Product / Process Change Notification (PCN)

PCN #: PCN_IndTI_20210425 Affected Series: WE-TI 7447467xxx, 744741xxx, 74473xxx, 7447721047, 744745xxx, 7447484xxx PCN Date: January 25, 2021 Effective Date: April 25, 2021	Change Category: <input type="checkbox"/> Equipment / Location <input checked="" type="checkbox"/> General Data <input type="checkbox"/> Material <input type="checkbox"/> Process <input type="checkbox"/> Product Design <input type="checkbox"/> Shipping / Packaging <input type="checkbox"/> Supplier <input type="checkbox"/> Software
Contact: Product Management Phone: +49 (0) 7942 - 945 5001 Fax: +49 (0) 7942 - 945 5179 E-Mail: pcn.eisos@we-online.com	Data Sheet Change: <input checked="" type="checkbox"/> Yes <input type="checkbox"/> No Attachment: <input type="checkbox"/> Yes <input checked="" type="checkbox"/> No

In line with internal standardisation, Würth Elektronik will unify the mechanical dimensions in the datasheets for the product series WE-TI.

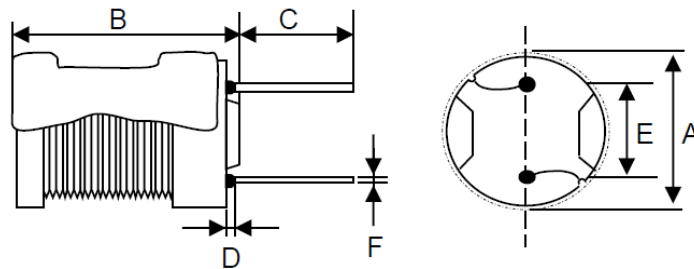
All affected articles are listed in the tables below.

The mechanical dimensions which will be changed are highlighted in yellow colour. The dimensions after the change are highlighted in green colour.

Part number	Before						After					
	A [mm]	B [mm]	C [mm]	D [mm]	E [mm]	F [mm]	A [mm]	B [mm]	C [mm]	D [mm]	E [mm]	F [mm]
7447467101	6 max	8,5 max	25 ± 1,0	2 max	2,5 ± 0,5	0,5 ref	6 max	8,5 max	25 ± 2,0	2 max	2,5 ± 0,5	0,5 ref
7447467102	6 max	8,5 max	25 ± 1,0	0,2 max	2,5 ± 0,5	0,5 ref	6 max	8,5 max	25 ± 2,0	2 max	2,5 ± 0,5	0,5 ref
7447467152	6 max	8,5 max	25 ± 1,0	2 max	2,5 ± 0,5	0,5 ref	6 max	8,5 max	25 ± 2,0	2 max	2,5 ± 0,5	0,5 ref
7447417102	9 max	6,5 max	25 ± 2,0	1 max	5 ± 0,5	0,65 ref	8,5 ± 0,5	5,5 ± 0,5	25 ± 2,0	1 max	5 ± 0,5	0,65 ref
7447417472	8,5 ± 0,5	5,5 ± 0,5	25 ± 1,0	1 max	5 ± 0,5	0,65 ref	8,5 ± 0,5	5,5 ± 0,5	25 ± 2,0	1 max	5 ± 0,5	0,65 ref
744732015	9,5 max	8 max	5 ± 0,5	1 max	5 ± 0,5	0,65 ref	9,5 max	8 max	5 ± 0,5	3 max	5 ± 0,5	0,65 ref
744732100	9,5 max	8 max	5 ± 0,5	1 max	5 ± 0,5	0,65 ref	9,5 max	8 max	5 ± 0,5	3 max	5 ± 0,5	0,65 ref
744732470	9,5 max	8 max	5 ± 0,5	1 max	5 ± 0,5	0,65 ref	9,5 max	8 max	5 ± 0,5	3 max	5 ± 0,5	0,65 ref

744732121	9,5 max	8 max	5 ± 0,5	1 max	5 ± 0,5	0,65 ref	9,5 max	8 max	5 ± 0,5	3 max	5 ± 0,5	0,65 ref
744732221	9,5 max	8 max	5 ± 0,5	1 max	5 ± 0,5	0,65 ref	9,5 max	8 max	5 ± 0,5	3 max	5 ± 0,5	0,65 ref
744732331	9,5 max	8 max	5 ± 0,5	1 max	5 ± 0,5	0,65 ref	9,5 max	8 max	5 ± 0,5	3 max	5 ± 0,5	0,65 ref
744732471	9,5 max	8 max	5 ± 0,5	1 max	5 ± 0,5	0,65 ref	9,5 max	8 max	5 ± 0,5	3 max	5 ± 0,5	0,65 ref
744732681	9,5 max	8 max	5 ± 0,5	1 max	5 ± 0,5	0,65 ref	9,5 max	8 max	5 ± 0,5	3 max	5 ± 0,5	0,65 ref
744732102	9,5 max	8 max	5 ± 0,5	1 max	5 ± 0,5	0,65 ref	9,5 max	8 max	5 ± 0,5	3 max	5 ± 0,5	0,65 ref
744732152	9,5 max	8 max	5 ± 0,5	1 max	5 ± 0,5	0,65 ref	9,5 max	8 max	5 ± 0,5	3 max	5 ± 0,5	0,65 ref
744732153	9,5 max	8 max	5 ± 0,5	1 max	5 ± 0,5	0,65 ref	9,5 max	8 max	5 ± 0,5	3 max	5 ± 0,5	0,65 ref
744736472	9,5 max	8 max	2,5 ± 0,5	2 max	5 ± 0,5	0,65 ref	9,5 max	8 max	2,5 ± 0,5	3 max	5 ± 0,5	0,65 ref
744737471	9,5 max	8 max	25 ± 2,0	3 max	5 ± 0,5	0,7 ref	9,5 max	8 max	25 ± 2,0	3 max	5 ± 0,5	0,65 ref

7447455472	9,5 max	13,5 max	25 ± 2,0	1 max	5 ± 0,5	0,65 ref	9,5 max	13,5 max	25 ± 2,0	2 max	5 ± 0,5	0,65 ref

744735472

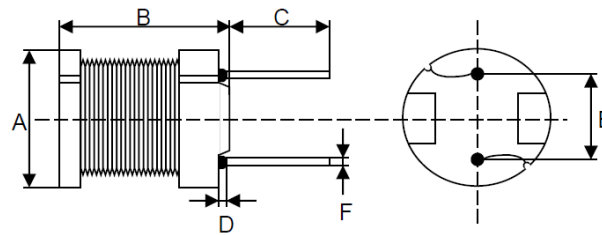
Part number	Before						After					
	A [mm]	B [mm]	C [mm]	D [mm]	E [mm]	F [mm]	A [mm]	B [mm]	C [mm]	D [mm]	E [mm]	F [mm]
7447410681	8 ± 0,5	5,5 ± 0,5	5 ± 1,0	1 max	5 ± 0,5	0,65 ref	7,8 ± 0,5	5,5 ± 0,5	5 ± 1,0	1 max	5 ± 0,5	0,65 ref
744730392	7,8 ± 0,5	7,5 max	5 ± 0,5	1 max	5 ± 0,5	0,65 ref	7,8 ± 0,5	7,5 max	5 ± 0,5	3 max	5 ± 0,5	0,65 ref
7447721047	7,8 ± 0,5	7,5 max	5 ± 0,5	1 max	5 ± 0,5	0,65 ref	7,8 ± 0,5	7,5 max	5 ± 0,5	3 max	5 ± 0,5	0,65 ref
744733472	7,8 ± 0,5	7,5 ± 0,5	2,5 ± 0,3	2 max	5 ± 0,5	0,65 ref	7,8 ± 0,5	8 max	2,5 ± 0,3	3 max	5 ± 0,5	0,65 ref
7447450103	9,5 max	13,5 max	3,5 ± 0,5	2 max	5 ± 0,5	0,65 ref	7,8 ± 0,5	12 ± 0,5	3,5 ± 0,5	2 max	5 ± 0,5	0,65 ref
7447484331	10,5 max	14,5 max	25 ± 1,0	2 max	5 ± 0,5	0,7 ref	10,5 max	14,5 max	25 ± 2,0	2 max	5 ± 0,5	0,7 ref
7447484102	10,5 max	14,5 max	25 ± 1,0	2 max	5 ± 0,5	0,7 ref	10,5 max	14,5 max	25 ± 2,0	2 max	5 ± 0,5	0,7 ref

Before			After		
A	8,5 ± 0,5	mm			
B	7,5 ± 0,5	mm			
C	7,0 ± 0,5	mm			
D	2,0 max.	mm			
E	5,0 ± 0,5	mm			
F	ø 0,65 ref	mm
